DEPARTMENT OF TRANSPORTATION**Federal Highway Administration****23 CFR Part 655**

National Standards for Traffic Control Devices; Revision of the Manual on Uniform Traffic Control Devices

ACTION: Final Amendments to the Manual on Uniform Traffic Control Devices (MUTCD).

R10-3b
225 mm x 300 mm
(9" x 12")

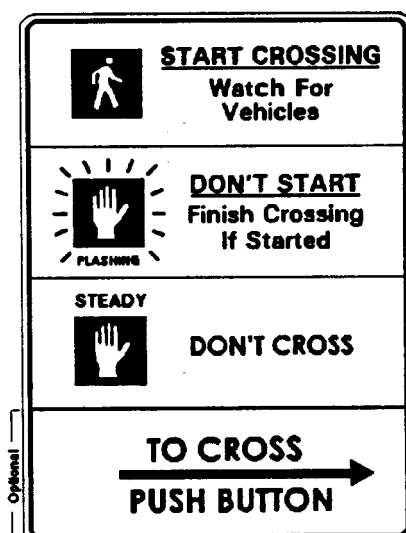
This amendment will allow the use of an educational plaque that can be used in conjunction with pedestrian signal indications. The FHWA is adopting the use of this optional educational plaque where both symbol-type and word message pedestrian signal indications are used.

A total of 27 of the 30 comments received agreed with the use of the educational plaque. The wording of the plaque shown in the notice of proposed rulemaking has been slightly modified to reflect the following comments:

1. After the wording DONT START use FINISH CROSSING IF STARTED.

2. Pedestrians should be aware of all vehicles, not just turning cars.

3. The highlighted flashing hand symbol is more easily understood.

4. All intersections do not have marked crosswalks.

5. Eliminate the wording WAIT ON CURB because all intersections do not have curbs.

6. Many intersections in the United States do not have push buttons for operating signals and, therefore, the bottom section of the sign with the caption "TO CROSS. . .PUSH BUTTON" should be made optional.

7. Since both symbols and word messages are allowed for pedestrian signal indications, two plaque designs are necessary.

Note: Word message (R10-3c) may be used in place of WALK/DON'T WALK symbol.
